Re: *Addendum No. 1*
Douglas Boulevard Reconstruction
City of Richmond Heights

Date: June 13, 2025

DOUGLAS BOULEVARD - PLAN VIEW
STA 32+00 TO STA 34+00

DOUGLAS BOULEVARD RECONSTRUCTION

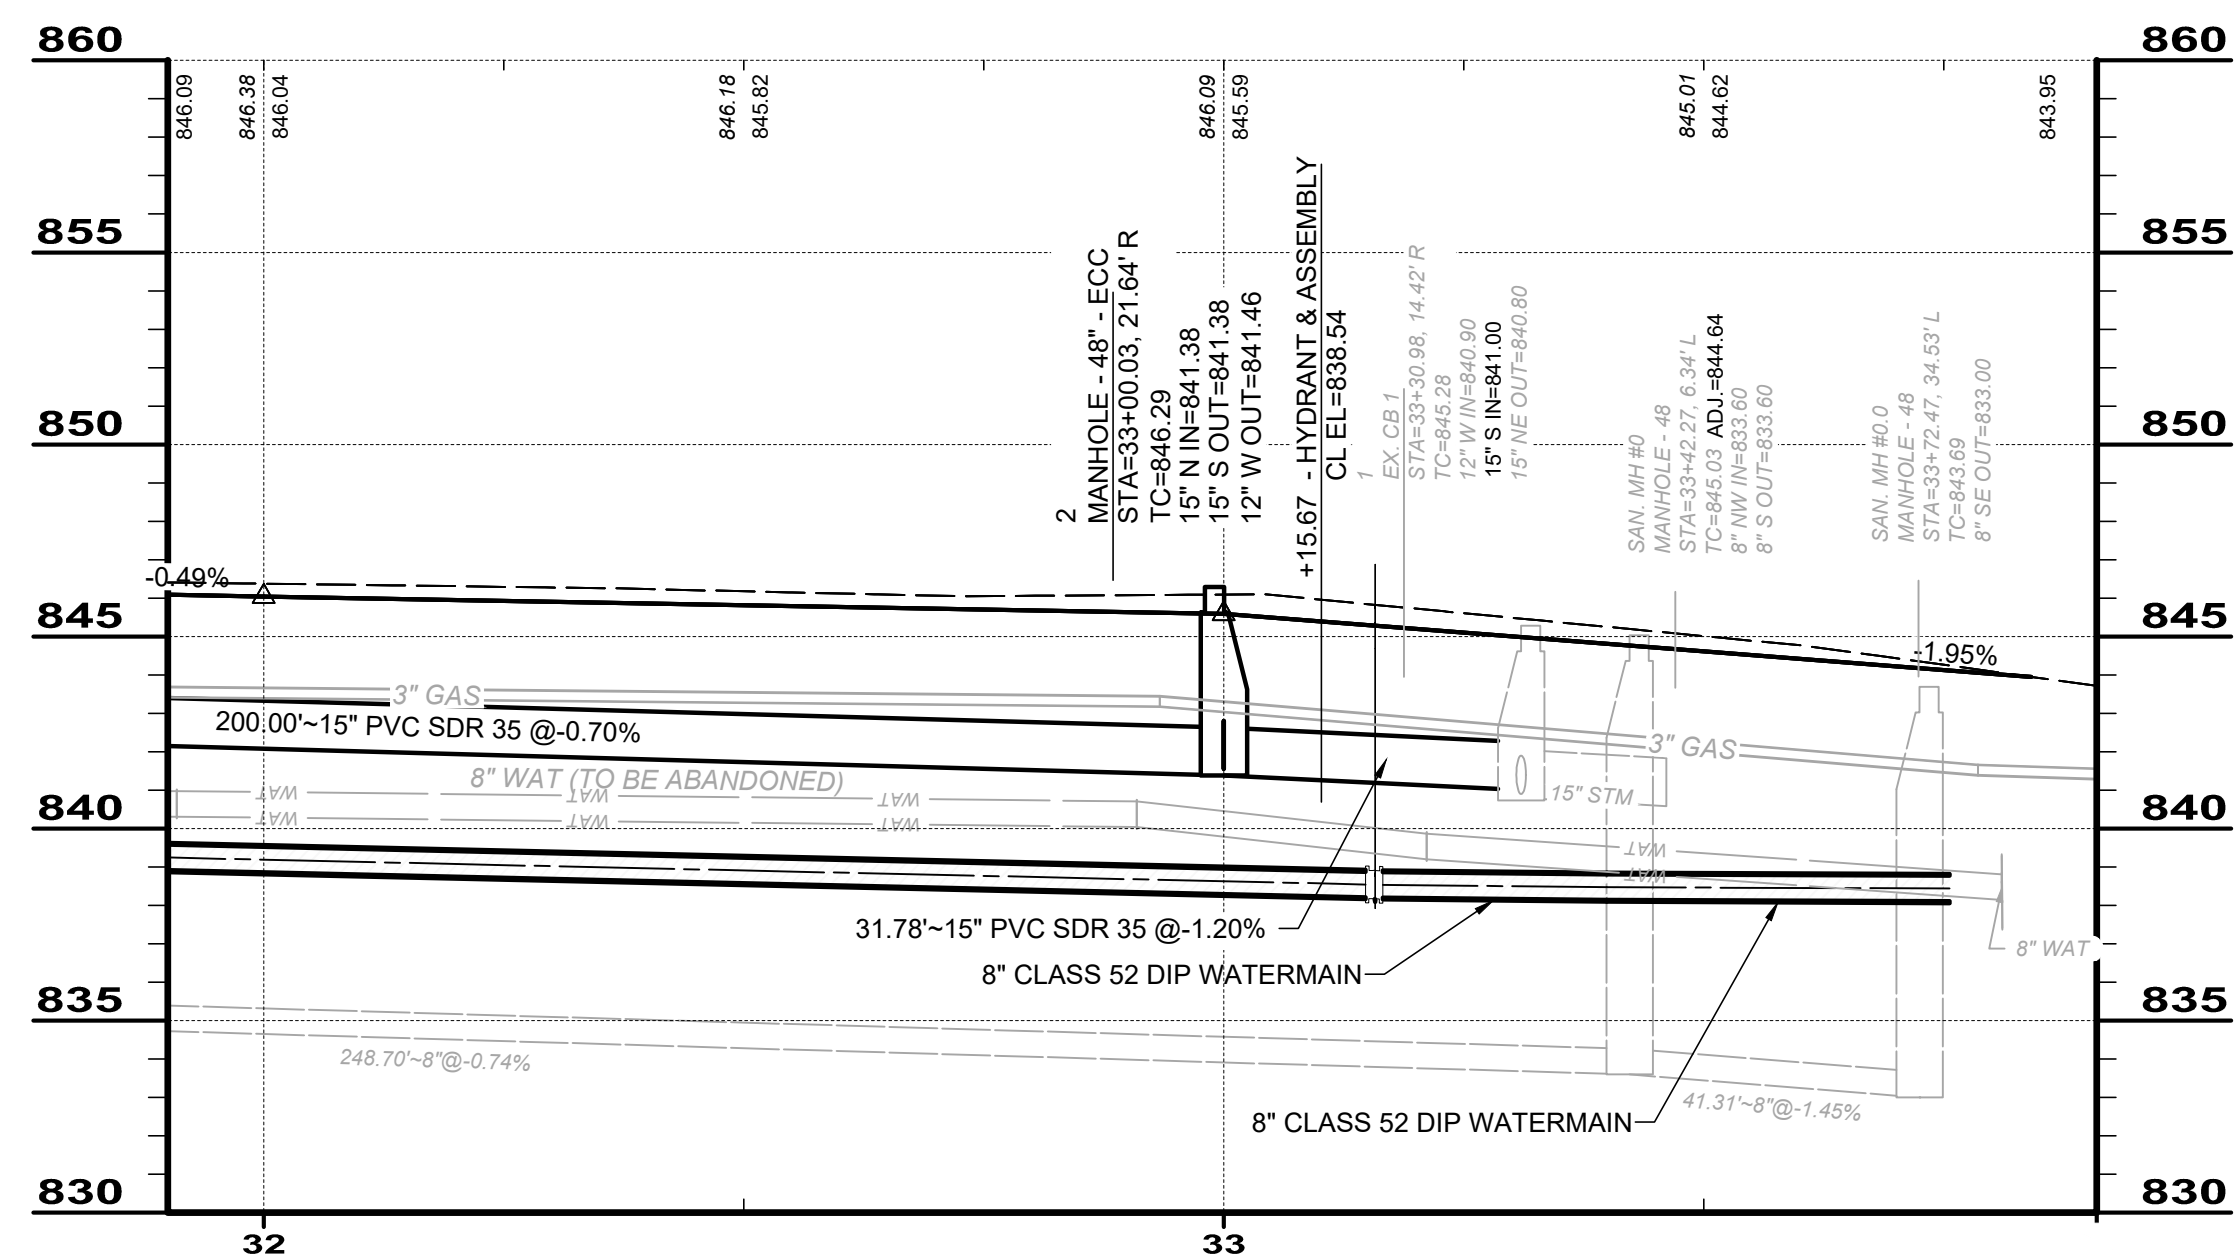
On plan sheet 18/39, the 8" valve was moved from station 33+40 to station 33+81

On plan sheets 14 through 18, the 4 Inch Shallow Pipe Underdrains should be **Revised** to 6 Inch to correspond with the Proposal Item Ref. No. 15 - 6 Inch Shallow Pipe Underdrains, As Per Plan.
